Monks Orchard Residents' Association Planning

Stage 1 Complaint – Planning Approval Ref: 19/04705/FUL; 16-18 Ash Tree Close Croydon CR0 7SR

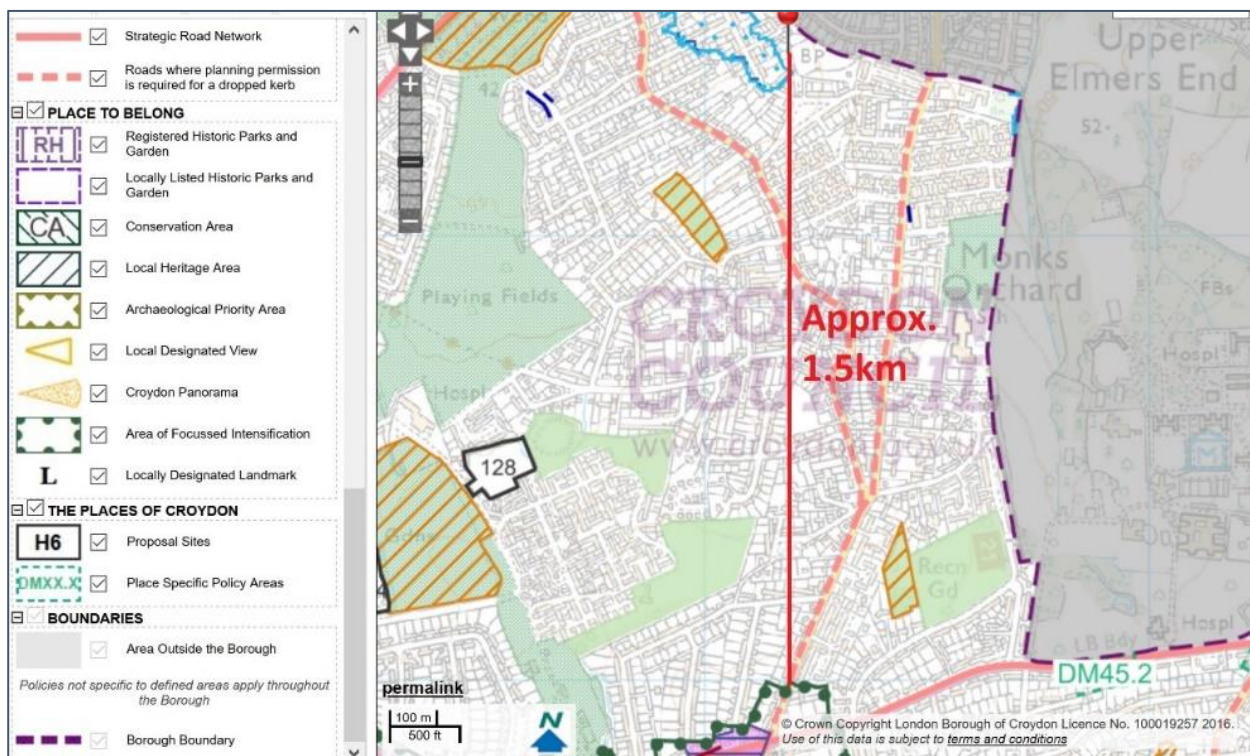
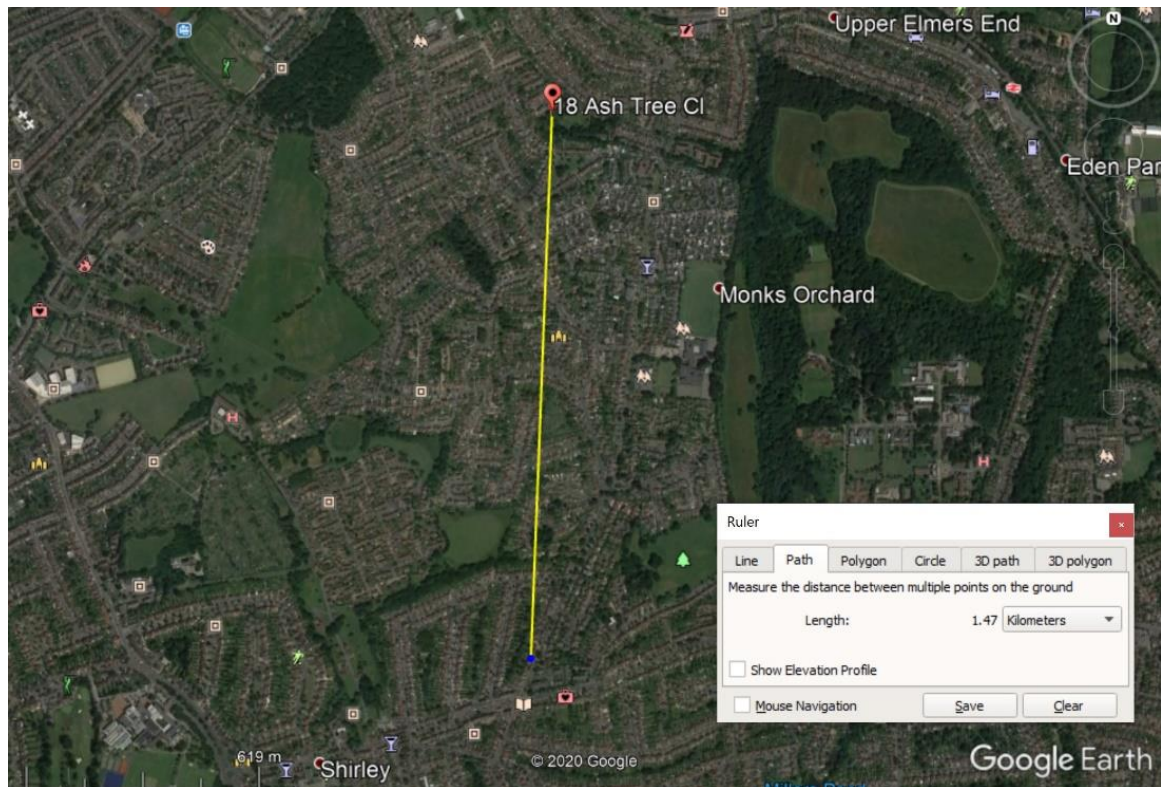
This Graph shows the conversion from **PTAL at 5.33** which requires a **TfL Access Index Range** between ≈ 21.5 to ≈ 30.0 for **Public Transport Accessibility** when the available Accessibility at **PTAL 1a** is actually between **0** and **2.5** for the localities **Public Transport Accessibility**.

Complaint #6: Can you provide justification, exactly why it is acceptable for a development of **Residential Density** at a **suburban setting** and **PTAL of 1a**, which should be in the "**broad ranges**" of **150 to 200hr/ha** equating to a **TfL Accessibility Level Range of 0 to 2.5**, Requires a Residential Density of **299.63hr/ha** in the **PTAL RANGE OF 4 TO 6** which equates to a **TfL Public Transport Accessibility Level requirement of between 21.5 to 30** ? (This requires a **63.73%** increase in **Residential Density** and a **707.58%** increase in required **PTAL** from the appropriate recommended level of **1a** (numerically 0.66) to **5.33** which is **UNSUSTAINABLE** as the **PTAL** is forecast to remain at **1a** until 2031.

Plot 1 Parking Bay Egress

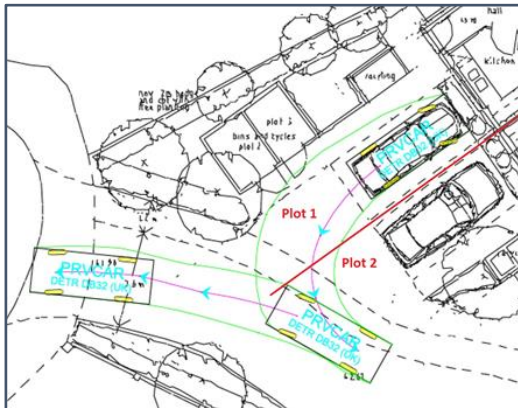
A good indication of **over-development** is that the **egress from parking spaces** require a **manoeuvre** which requires **mounting the access pathway and on occasions, actually entering the curtilage of other dwellings NOT associated with the parking space allocation** and **this would prevail for the life of the development.**

The future occupants of **Plot 2** would likely object to this necessary manoeuvre for the life of the development as an inconvenience which could cause conflict for the life of the development.

The owner occupier of **Plot 1 &/or Plot 2** or occupants may wish to erect a **boundary fence** to extend to the footpath in order to define their **curtilage of responsibility** and maintenance which would prevent further manoeuvres of egress of a forward parked vehicle from exiting **Plot 1** Parking Bay.

Plot 2 Parking Bay Egress

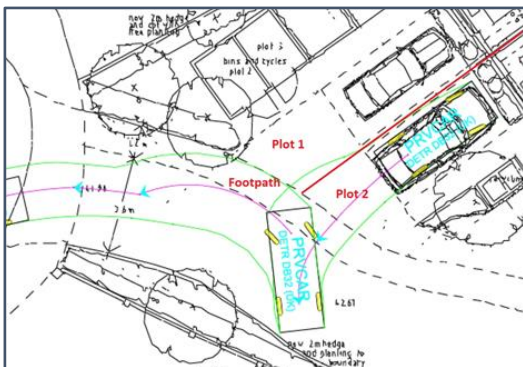
The Swept path diagram for Parking Bay **Plot 2** indicates the difficulty exiting the parking bay in reverse gear in order to exit the driveway in a forward gear into Ash Tree Close roadway.

The new swept path diagram shows that it is necessary to encroach over the curtilage of **Plot 1** Forecourt and then necessary to change into a forward gear and mount the access footpath in front of **Plot 1** in order to exit in a forward gear into Ash Tree Close.

The future occupants of **Plot 1** would likely object to this necessary manoeuvre for the life of the development as an inconvenience which could cause conflict for the life of the development. The owner occupier of **Plot 1 or 2** may wish to erect a **boundary fence** to extend to the footpath in order to define the **curtilage of their responsibility** and maintenance which would prevent further manoeuvres of egress of a forward parked vehicle from exiting **Plot 2** Parking Bay.

Plot 3 Parking Bay Egress

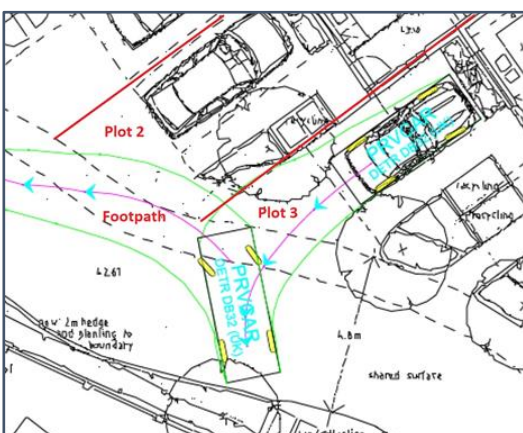
The Swept path diagram for Parking Bay **Plot 3** indicates the difficulty exiting parking bay in reverse gear in order to exit the driveway in a forward gear into Ash Tree Close.

The new swept path diagram shows that it is necessary to encroach over the curtilage of **Plot 2** Forecourt and then necessary to change into a forward gear and mount the access footpath in front of **Plot 2** in order to exit in a forward gear into Ash Tree Close.

The future occupants of **Plot 2** would likely object to this necessary manoeuvre for the life of the development as an inconvenience which could cause conflict for the life of the development.

The owner occupier of **Plot 2** may wish to erect a **boundary fence** to extend to the footpath in order to define their **curtilage of responsibility** and maintenance which would prevent further manoeuvres of egress of a forward parked vehicle from exiting **Plot 3** Parking Bay.

Plot 6 Parking Bay Egress

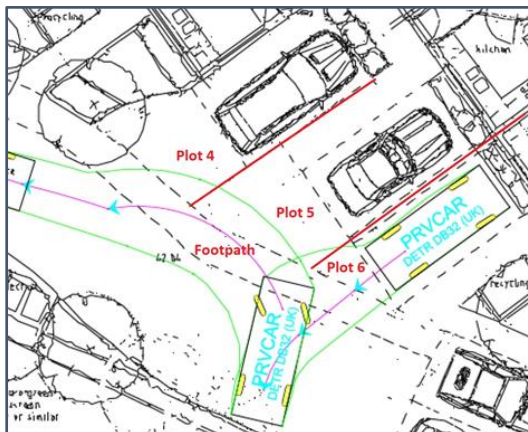
The Swept path diagram for Parking Bay for **Plot 6** indicates the difficulty exiting parking bay in reverse gear in order to exit the driveway in a forward gear into Ash Tree Close roadway. The new swept path diagram shows that it is necessary to encroach over the curtilage of **Plot 4 & 5** Forecourt and mount the access footpath in front of **Plot 4 & 5** in order to exit in a forward gear into Ash Tree Close. The future occupants of **Plots 4 & 5** would likely object to this necessary manoeuvre for the life of the development as an inconvenience which could cause conflict for the life of the development.

The owner occupier of **Plots 4 & 5** may wish to erect a **boundary fence** to extend to the footpath in order to define the **curtilage of their responsibilities** and maintenance which would prevent further manoeuvres of egress of a forward parked vehicle from exiting **Plot 6** Parking Bay.

Plot 7 Parking Bay Egress

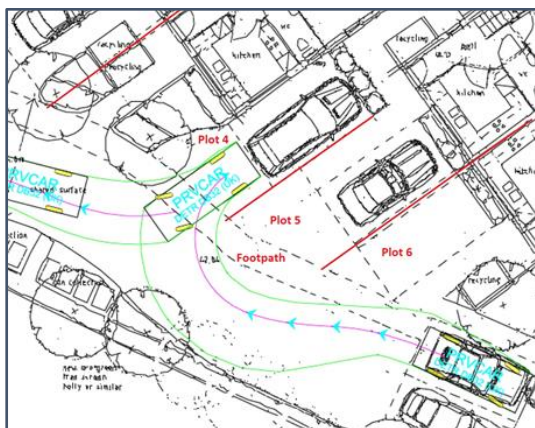
The Swept path diagram for Parking Bay **Plot 7** indicates the difficulty exiting parking bay in reverse gear in order to exit the driveway in a forward gear into Ash Tree Close roadway. The new swept path diagram shows that it is necessary to mount the footpath and encroach into the forecourt within the curtilage of **Plot 4** in a reverse gear before engaging a forward gear, mounting the access footpath in front of **Plot 4** in order to exit in a forward gear into Ash Tree Close.

The future occupants of **Plot 4** would likely object to this necessary manoeuvre for the life of the development as an inconvenience which could cause conflict for the life of the development.

Plot 8 Parking Bay Egress

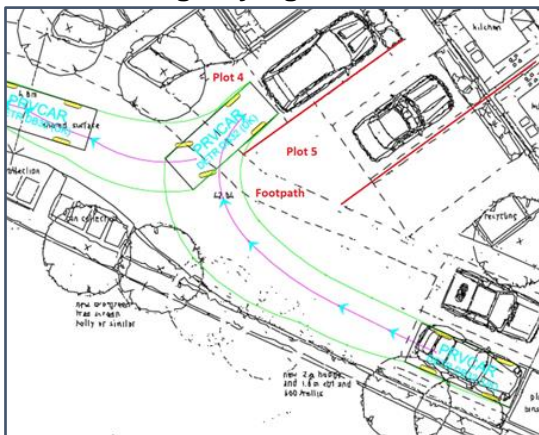
The Swept path diagram for Parking Bay **Plot 8** indicates the difficulty exiting parking bay in reverse gear in order to exit the driveway in a forward gear into Ash Tree Close roadway.

The new swept path diagram shows that it is necessary to mount the footpath and encroach into the forecourt within the curtilage of **Plot 4** in a reverse gear before engaging a forward gear, mounting the access footpath in front of **Plot 4** in order to exit in a forward gear into Ash Tree Close.

The future occupants of **Plot 4** would likely object to this necessary manoeuvre for the life of the development as an inconvenience which could cause conflict for the life of the development.
